Refer to NMFS No.: WCR-2018-11034

Re: Endangered Species Act Section 7 Formal Consultation and Magnuson-Stevens Fishery Conservation and Management Act Essential Fish Habitat Consultation for the Hells Canyon Creek Boat Ramp Repair Project, Snake River-Butte Creek Subwatershed, HUC 170601010102, Wallowa County, Oregon

**Endangered Species Act Section 7(a)(2) Biological Opinion and
Magnuson-Stevens Fishery Conservation and Management Act
Essential Fish Habitat Consultation**

Hells Canyon Creek Boat Ramp Repair Project, Wallowa County, Oregon
Snake River-Butte Creek Subwatershed, HUC 170601010102

Figure 1. Boat Ramp Scour Areas (WWNF 2018).

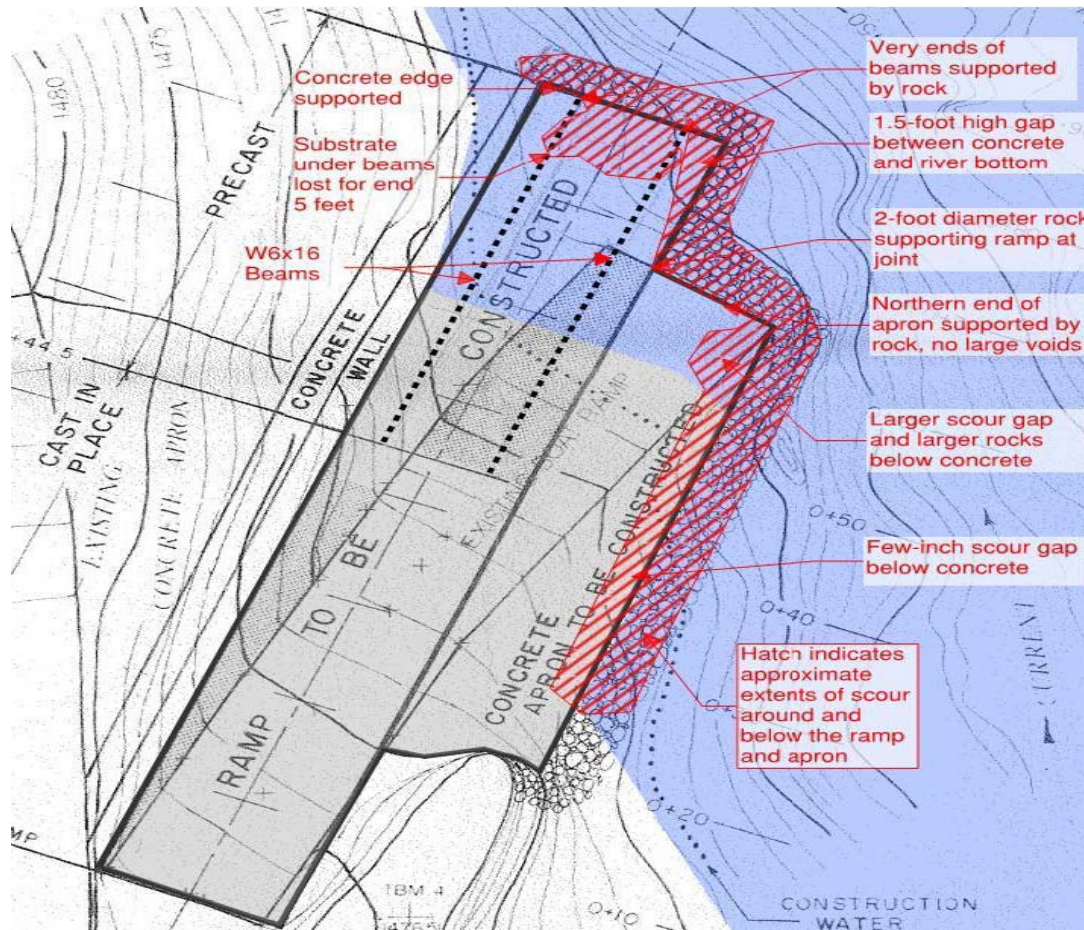
- 1) Underpin the concrete apron and boat ramp to provide structural support and prevent structural settlement (Figure 1). Additionally, precast curbs will be installed at the end of the boat ramp to prevent users from backing trailers off the launch ramp; and,
- 2) Stabilize the in-water slope along the perimeter of the boat ramp and apron with riprap to prevent future undermining of the structure.

- 1) Grout bags will be placed beneath the apron and boat ramp perimeter in areas that have been undermined. The grout bags will be filled with grout from the surface in shallow water, or by divers in deeper water. If necessary, a level pad will be constructed out of

Repairing the boat ramp and apron requires the underwater application of cement-based grout. Grout will be pumped into grout bags for placement below the perimeter of the structure, and will also be pumped into voids beneath the structure. An underwater cement-based patching compound may also be used to seal any remaining voids. The primary water quality parameter affected by placing grout underwater is pH (Fitch 2003). In-water grout application can cause pH values to exceed 11.0 in certain conditions (Fitch 2003). Aquatic organisms generally prefer pH between 6.5 and 8.0 (Addy et al. 2004). Changes in pH value due to grouting can be harmful, and potentially lethal, to salmonids depending on the degree of change and duration of exposure (McLeay 1983). A study by Witschi and Ziebell (1979) found that juvenile salmonids display sluggish behavior or loss of equilibrium when exposed to pH 9.0 water. Additionally, exposure to pH 9.0 water for 30 minutes or longer may cause elevated oxygen consumption rate and a greater rate of coughing among juvenile salmonids, in comparison to salmonids in water with ordinary pH values (Hargis 1976). Water with a pH value of 10.0 or greater is likely to be rapidly lethal to salmonids, regardless of life stage (McLeay 1983).

Elevated pH values have the potential to cause harm to salmonids present within the eddy due to slower dilution rates and proximity to the project site. If pH values exceed 9.0 during monitoring efforts, the grouting operation will be shut down, evaluated, and methods will be revised prior to the continuation of grouting. This, in addition to the other BMPs associated with the grouting activities, will effectively minimize this risk to ESA-listed salmonids in the action area.

- b. Ensure that the construction contractor or WWNF personnel visually monitor boat ramp repair efforts during grouting activities for significant seepage of grout from grout bags or voids. In the event of significant seepage, the grouting activity will immediately cease and pH values will be monitored. Grout application methods will be revised prior to continuation of grouting. Any significant seepage with correlation to elevated pH values should be recorded.

Figure 2. Cross Section of Boat Ramp with Riprap Placement (WWNF 2018).

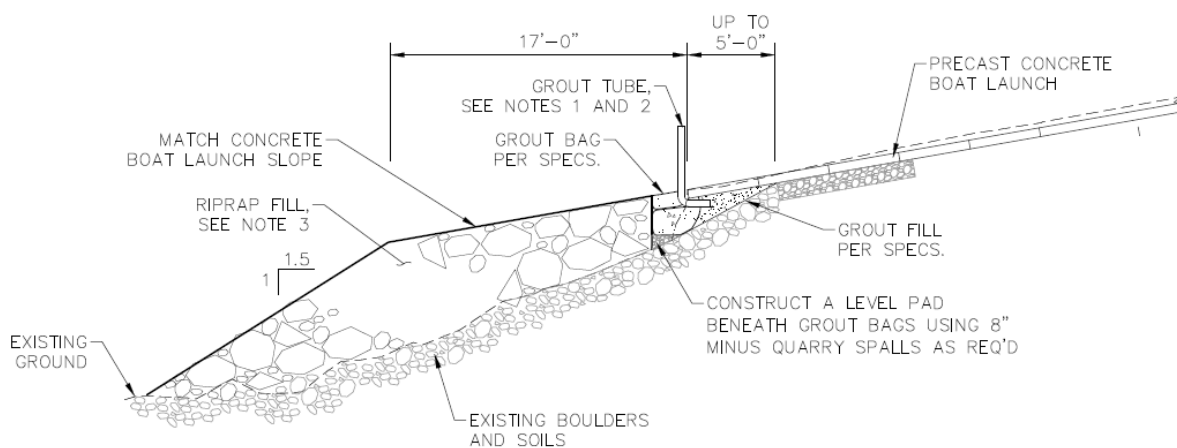
In addition to the boat ramp repair, approximately 632 cubic yards of riprap will be installed adjacent to the boat ramp and apron to stabilize the in-water slopes and protect the structure from future undermining (Figure 2). The placed riprap will match the slope of the boat ramp and apron on the river-adjacent sides of the structure for approximately 15 feet, and will then maintain a 1-foot rise by 1.5-foot run slope downward until meeting the existing river bottom. Overall, the riprap will extend approximately 30 feet into the river channel from the boat ramp. Rock size will vary between 15-inch and 42-inch diameters. The large volume and variation in size of riprap will reduce the risk of localized scouring. Installation of the riprap will require in-channel equipment operation. A loader and rock truck will deliver riprap material from the stockpile to the boat ramp. The material will be dumped at the top of the placement area and pushed into place with a large excavator bucket. The excavator will be the only equipment operating within the channel, and will only operate from the top of the boat ramp and on paved areas along the shore.

The project will utilize approximately 632 cubic yards of riprap, which will occupy 525 square feet of the river channel cross section. Riprap will be placed up to 30 feet into the channel from the bank, affecting 17 percent of the total channel width (174 feet wide in during normal summer flows). Since riprap placement and potential mobilized riprap will only affect a small portion of the river channel, fish will be able to relocate to nearby suitable habitat. It will not be feasible to monitor the number of fish injured or killed as a result of riprap placement.

Natural cover could be slightly negatively affected due to the installation of riprap adjacent to the boat ramp. Natural cover could also be slightly negatively affected due to the installation of fill in the voids underneath the boat ramp and apron, which could be acting as an artificial undercut bank for fish. Approximately 632 cubic yards of riprap will be installed, decreasing the channel area by approximately 525 square feet. The riprap will be large coarse rock, ranging from

approximately 15 inches to 42 inches in diameter. The proposed riprap will be similar in volume and area to the original fill that the boat ramp was constructed on. However, the installed riprap will be larger diameter than the original fill used in order to protect the boat ramp structure from future high flow events. The decrease in channel area is expected to have minor negative effects on natural cover, while the increase in rock size in comparison to the original fill could partially offset this effect by providing a small amount of natural cover. Since the boat ramp did not have voids upon original installation, filling of the voids will restore the structure and site to reduced natural cover. Because of these project design characteristics, the project is not likely to change the function of the natural cover PBF in the long term.

mobilized riprap during project construction. That being the case, NMFS will use the volume of riprap placed within the river channel as a surrogate for take. This is a rational surrogate for take because the greater volume of riprap used, the greater amount of take that would occur. Although this surrogate could be considered coextensive with the proposed action, monitoring and reporting requirements will provide opportunities to check throughout the course of the proposed action whether the surrogate is exceeded. For this reason, the surrogate functions as an effective reinitiation trigger. NMFS will consider the extent of take exceeded if more than 750 cubic yards of riprap is placed within the river channel.
